DESIGN REVIEW: RECOMMENDATION

1422 SENECA STREET, SEATTLE, WA 98101

PROJECT #:3034493-EG

ANALYSIS: ZONE TRANSITION / SITE SECTIONS [5.5]

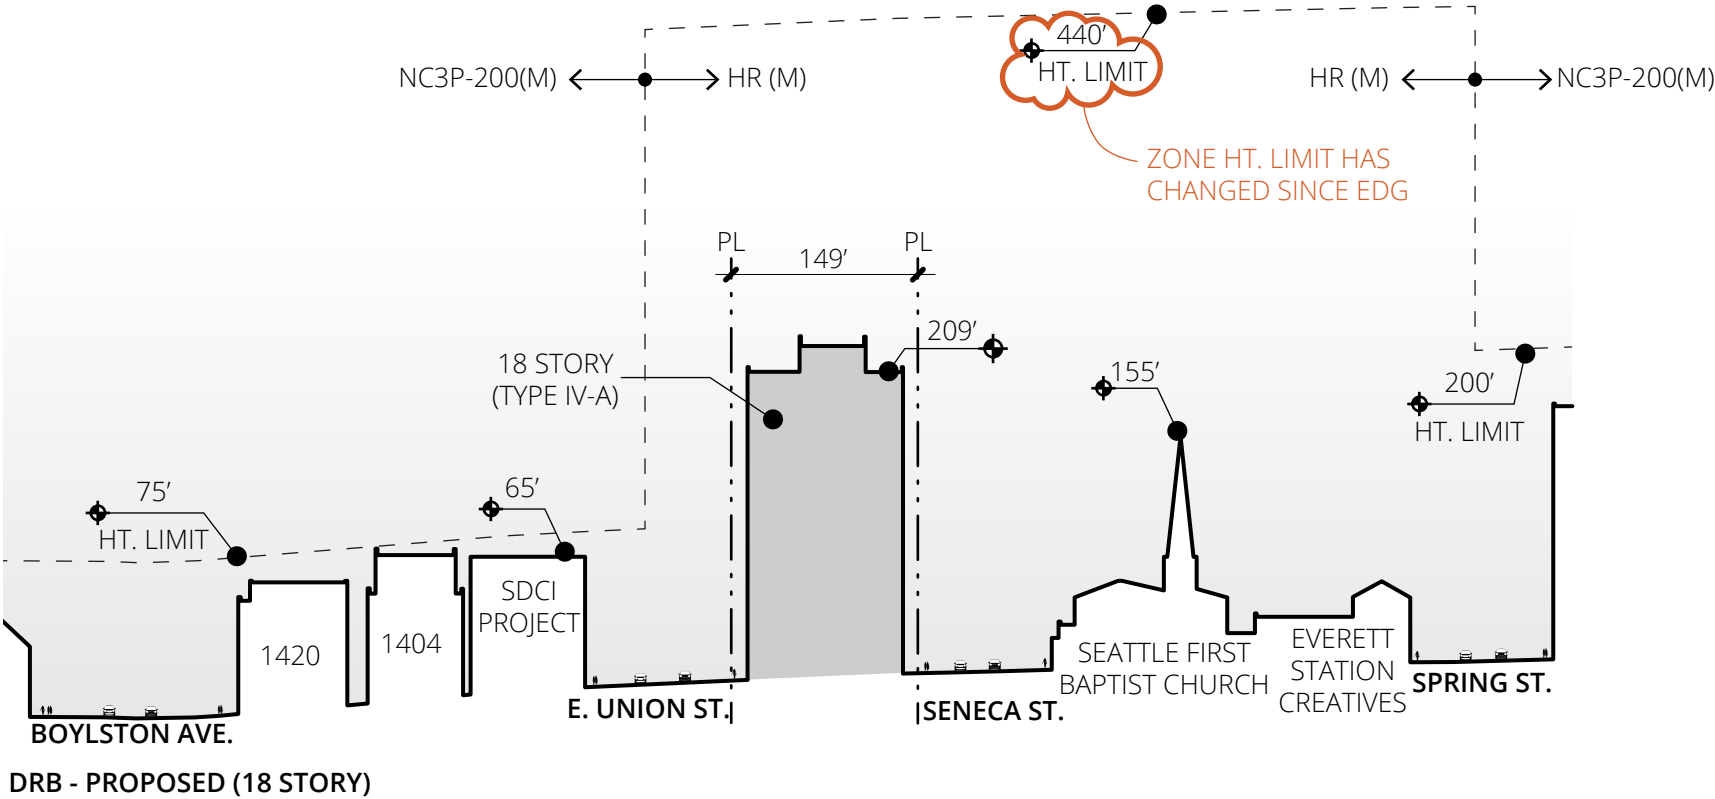
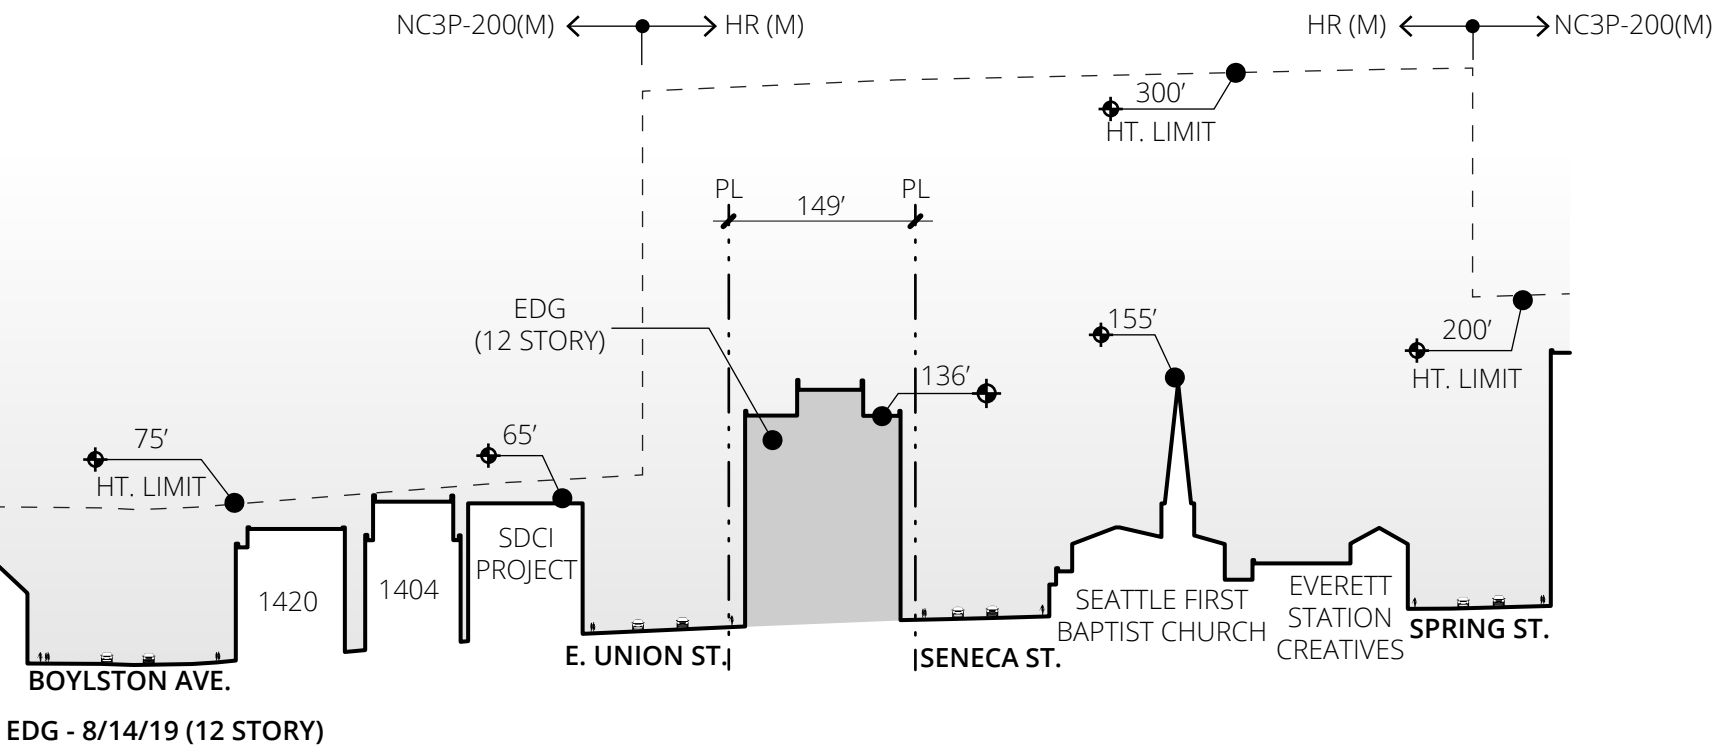
**ZONE
TRANSITIONS
(CS2.D.3)**

The Board recognized the eclectic character of First Hill and it's history as a location for new design style typologies, and urged that this project could be an appropriate addition.

The site is located on a prominent transition between downtown high-rise and adjacent low rise buildings. The 18 story proposed project is 209' (224' to top of penthouse) which transitions the scale from 440' height limit to the 75' height limit. The project will use mass timber for the structural system.

DRB - PROPOSED (18 STORY)

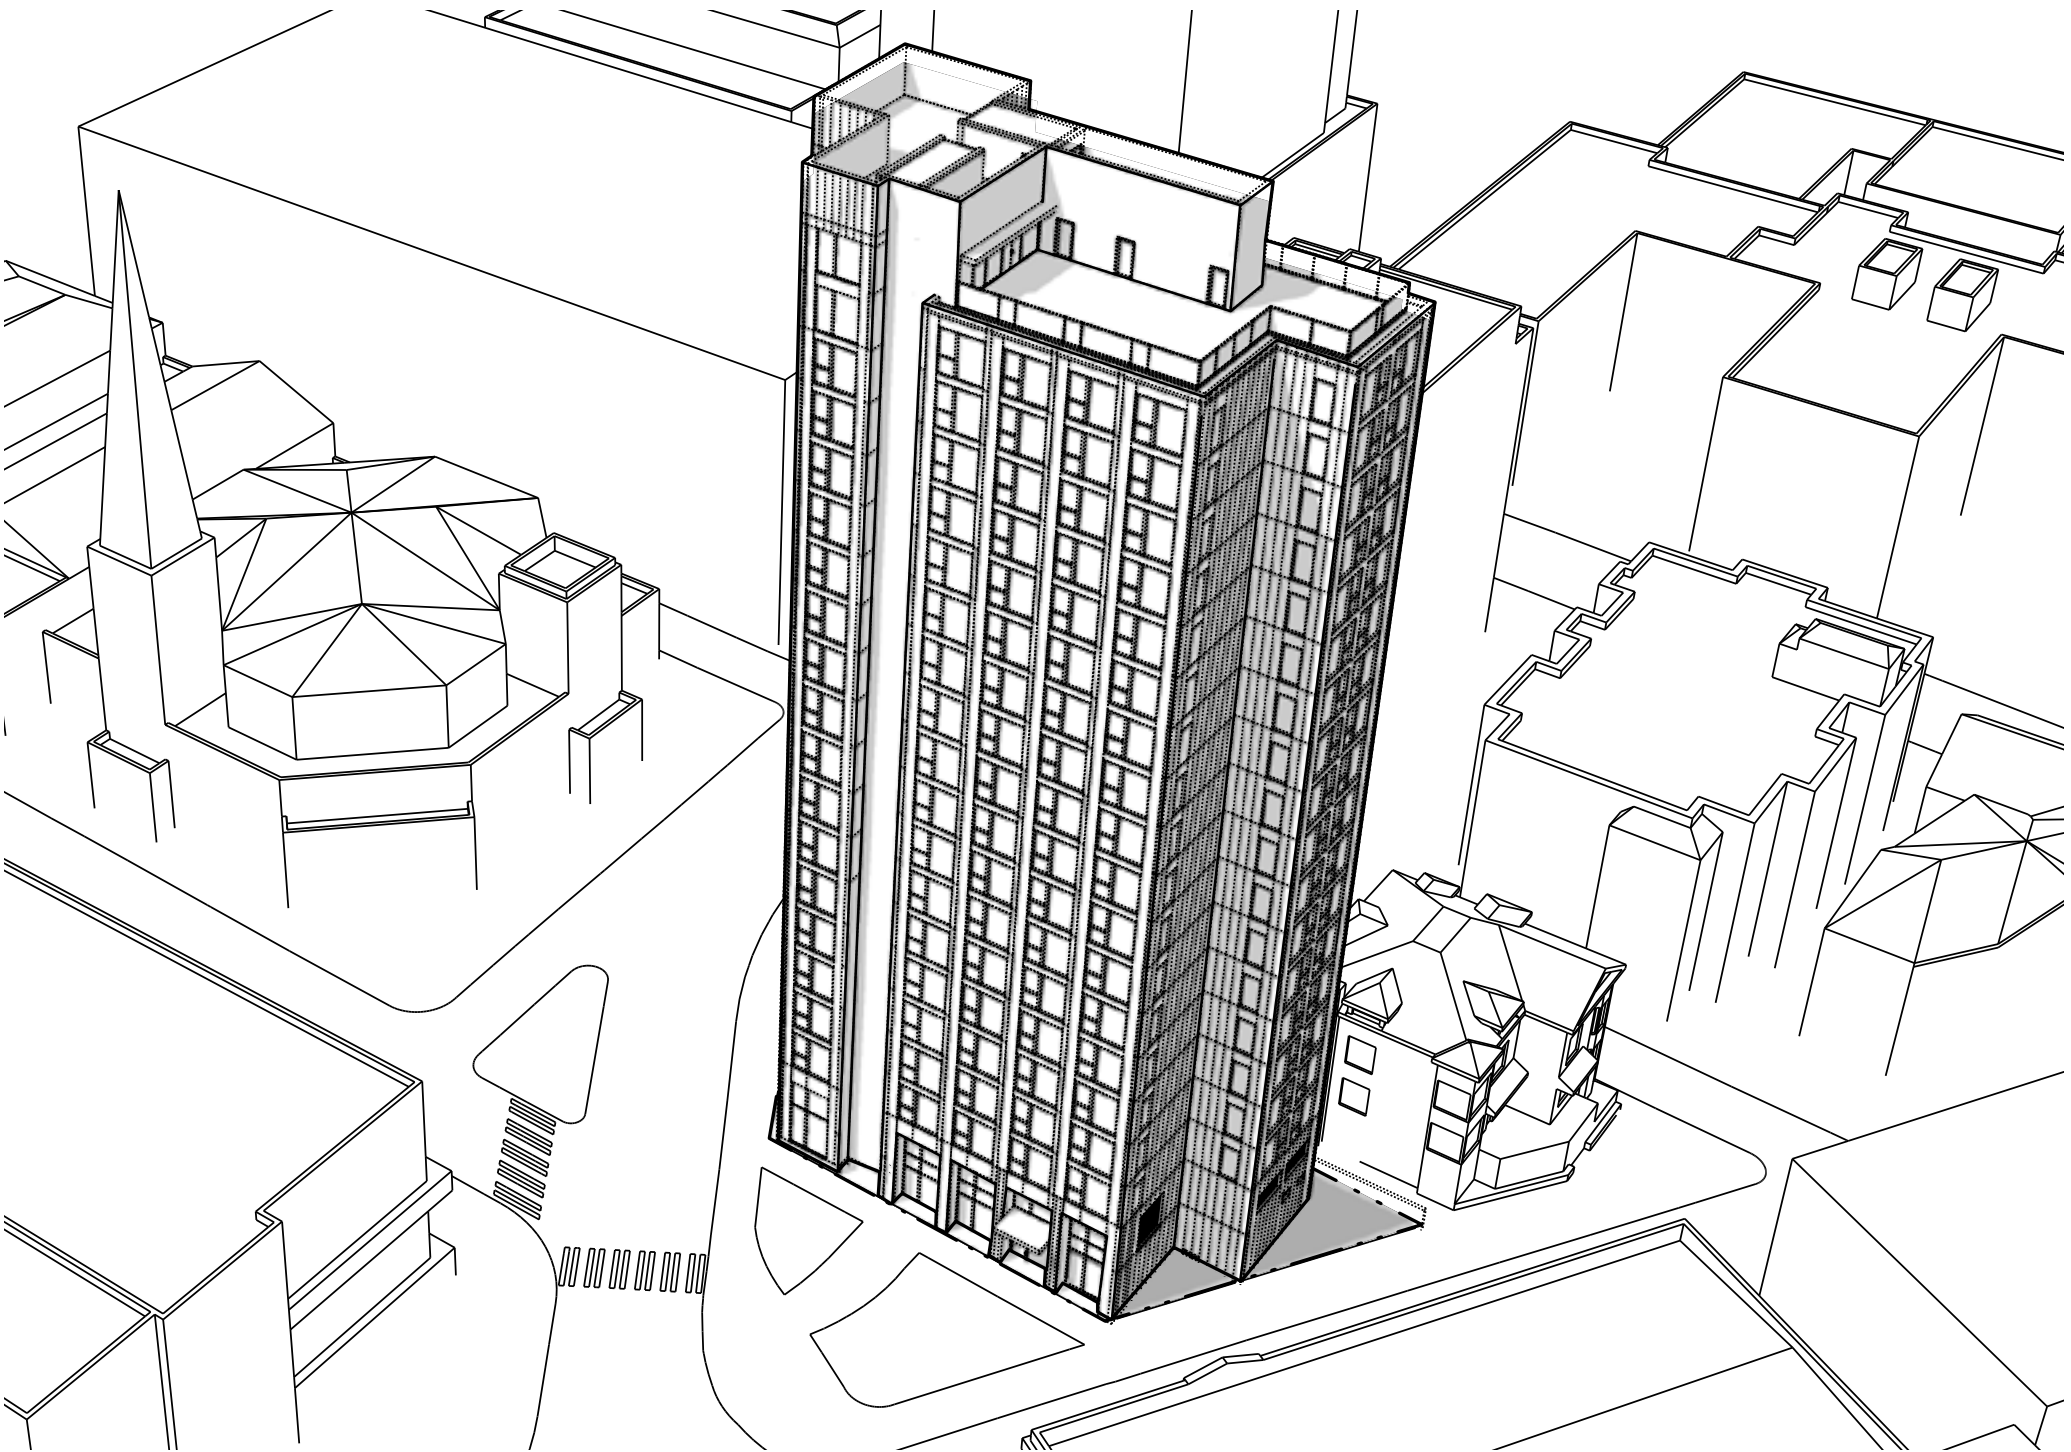
CORNER SITES
(CS2.C.1)

The Board supported the thinness of the massing for both it's expression of the innovative construction type and it's potential to lessen impacts on light and air on adjacent sites and streets.

EXTERIOR
EXPRESSION
(DC2.B.1)

The Board expressed concerns regarding the roof canopy expression in the preferred option, and requested further study of this element and it's role in the larger composition.

Building massing is consistent with the early design guidance preferred scheme. The triangular shaped lot allows the building to step back from adjacent streets, while the proposed courtyard minimizes light and air impacts on adjacent buildings.

The secondary roof canopy has been removed and the south massing has been extended to integrate a smaller canopy at the elevator penthouse.

DRB - PROPOSED (18 STORY)

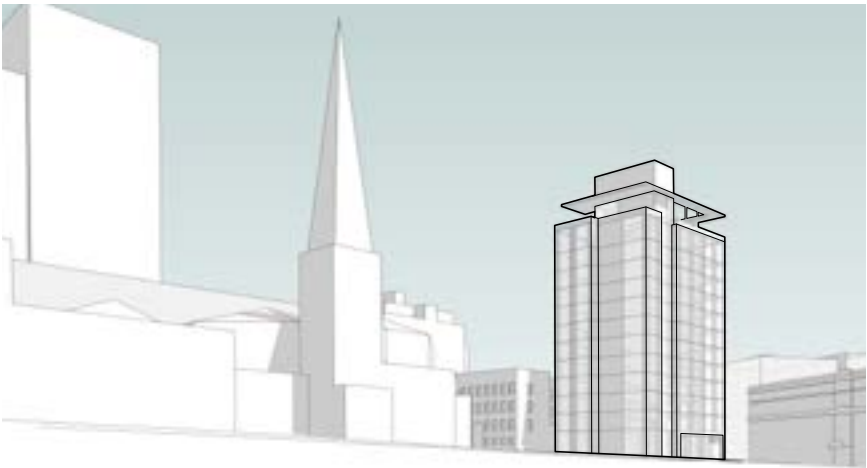
FITTING OLD AND
NEW TOGETHER
(CS3.A.1)

The Board questioned the connection between the height of this project and that of the spire at the landmarked Seattle First Baptist Church, and asked that a more rigorous conceptual analysis be developed of the forms in this neighborhood and this proposals response to that context.

The height of the building is not tied to the church spire, rather the height is an intermediate tower that is appropriate at the edge of the highrise zone. The building takes advantage of views to Seattle First Baptist Church.

EDG RESPONSE - GROUND FLOOR RESOLUTION [8.0]

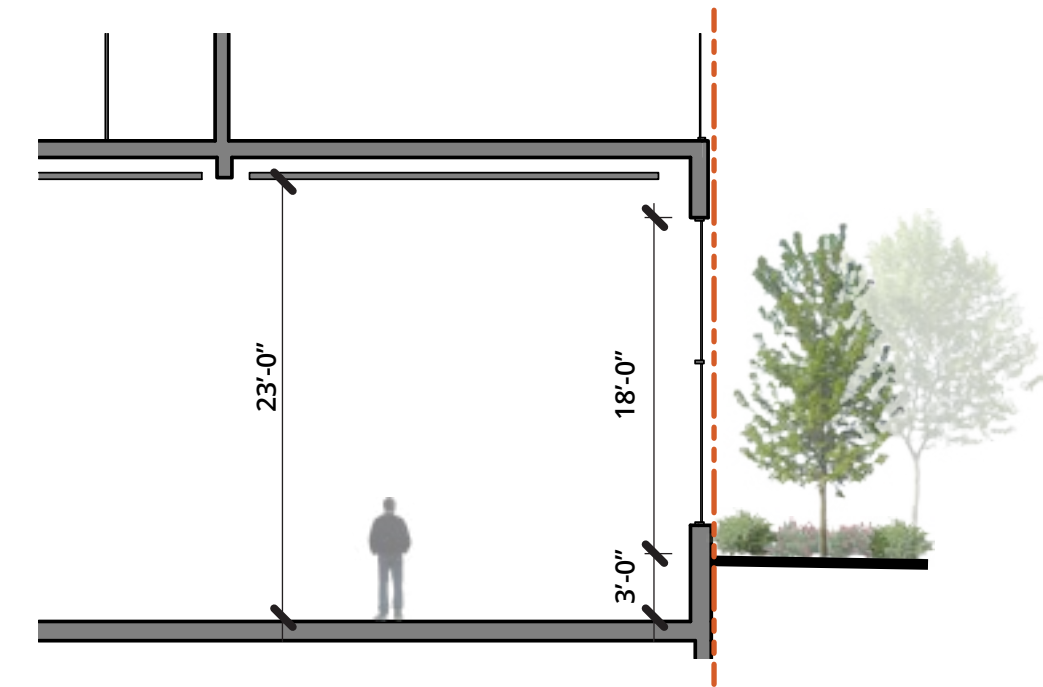
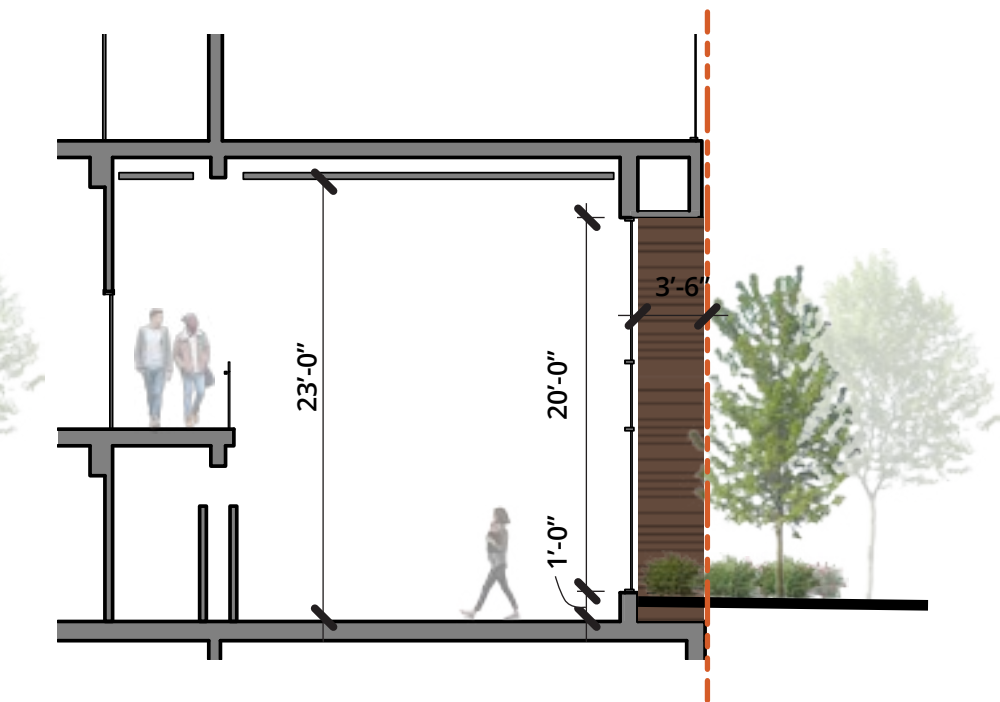
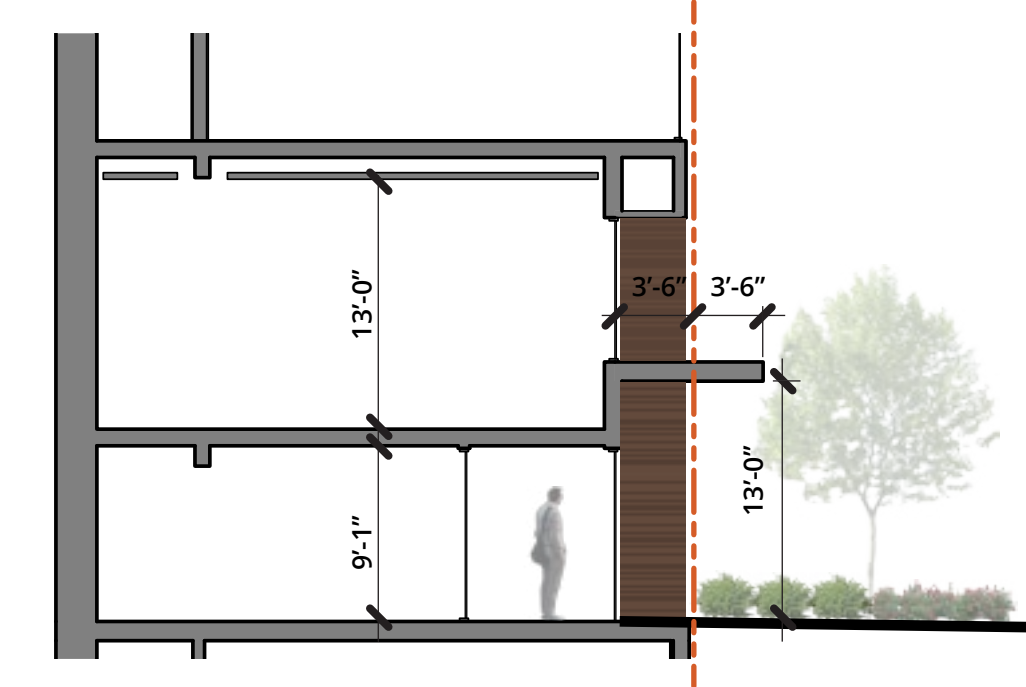
POROUS EDGE
(PL3.C.1)

The Board was concerned to find few details regarding the design of the ground plane and pedestrian experience. The Board provided guidance with those edges should activate the sidewalk without appropriating the associated public spaces, and that complete details be provided for the next meeting, including entrance locations, inside/ outside relationships, resolution of grade issues, and the courtyard area fronting Maxmillian apartments.

CONNECTION
TO OTHER OPEN
SPACE
(DC3.B.3)

The Board recognized that the park-like triangle of space directly north east of the site is part of the city right of way, but emphasized how important the development of this space would be to the pedestrian experience of this project.

The public right of way will be developed as part of this proposal to create a neighborhood amenity with public seating, lighting and gathering space. Sections provided at the ground floor transitions represent the resolution in grade through landscaped areas.

The public plaza will include public seating, lighting and gathering space. The primary residential entry is accessible from the new plaza. The public plaza will add to the evolving First Hill network of public spaces. See landscape for more details.

ENLARGED SITE PLAN OF BUS STOP

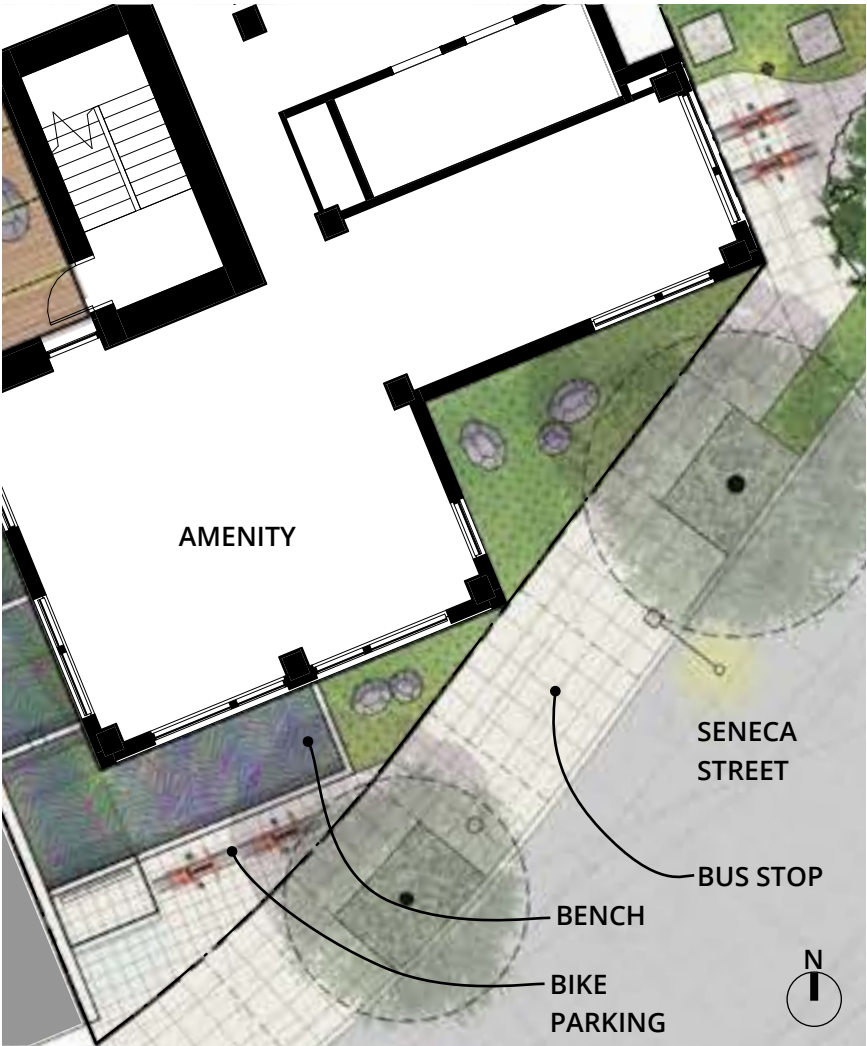
ON-SITE TRANSIT
STOPS
(PL4.C.2)

The Board supported the provision of additional space for the bus stop on Seneca St.

The Building massing is setback at the bus stop to provide relief at the bus stop. The landscape plan has been developed to include benches and additional paving as a benefit to public transit riders along Seneca Street.
